Tnakita

99132

► Modification of Controller

For Models | HM1214C, HM1307C, HM1307CB, HM1317C, HM1317CB

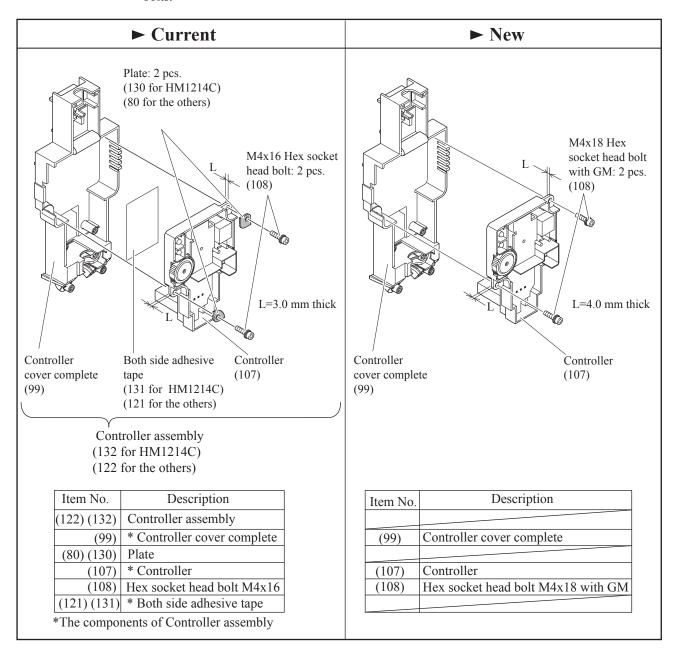
Material of Controller case has been changed for further improvement in the durability. Both side adhesive tape and two Plates (Re: our previous Technical information No. 91793) have been eliminated.

Thickness of screw fastening portions of Controller case has been changed from 3 mm to 4.5 mm, and therefore, M4x16 Hex socket head bolts have been replaced with M4x18 Hex socket head bolts.
